RE: Centennial Train Track Maintenance

RE: Inspection of Acme Park train bridge

City of Clinton, Acme Brick Park Train Bridge

4 - 50' I - BEAM SPAN

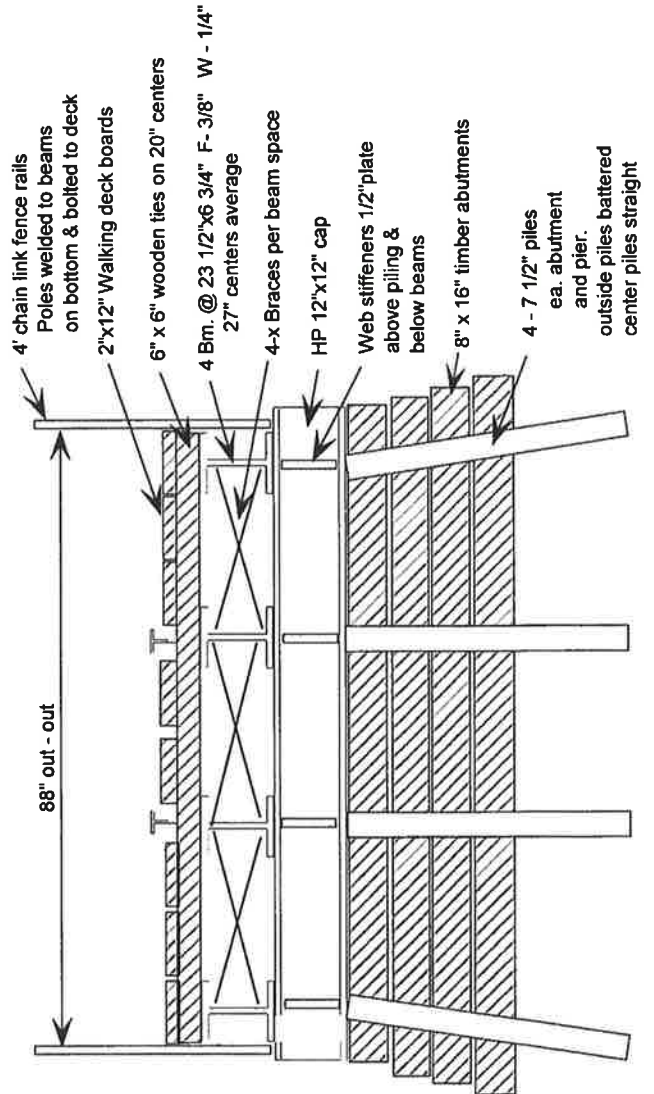
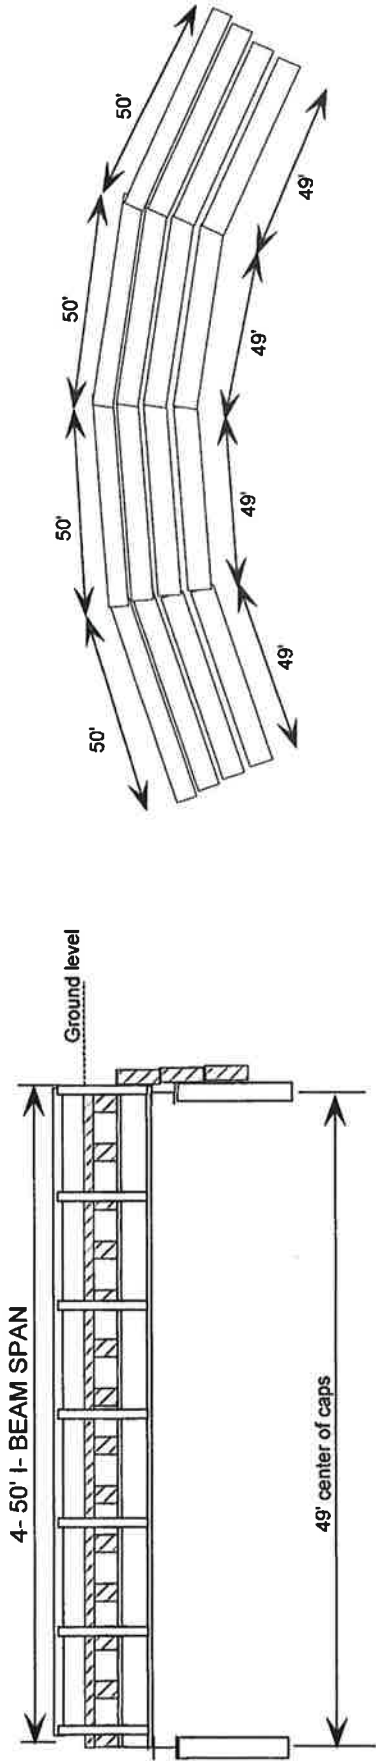
Beams are straight and cut slightly shorter on each beam to make the arch in 4 spans. West beam = 50'. East beam = 49', Beams #2 = 49' 9". Beam #3 = 49'3. Beams spaced at different widths. Train tracks sit above beams #2 and 3 flanges for the most part. Over all out – out = 88", average spacing = 27"

X sway brace on bottom of beams is all still in place and working. Has several welds that were just tacked. 1 tack in #4 span (south) has broken on the outer edge of beam flange. Several others are just ½" short tack welds, but still good.

Piles #1 and 4 are battered, piles #2 and 3 are straight. No determination on depth.

12"x12" H-beams are structurally good, Minor rust in places on lower flange where soil has built up. Web stiffeners are all in place and welds good. Paint is still mostly there except where soil piled up and rust has caused paint to fail in these locations, light chalking on rest.

7 ½" piles are structurally good, Light rust starts 8' down from cap and down through water line. No visual exfoliation on rusted areas. Paint above the water line is good and covering with light chalking.

1. Replace the broken timber plank between the rails on the East end of the deck to avoid a potential pedestrian being injured by it.
2. Re-weld the broken weld of the sway brace noted earlier.
3. Monitor the pier columns in the water/splash zone periodically to insure the rusting there doesn't progress to where enough section of pipe pile is rusted away to negatively affect the load capacity of the members.
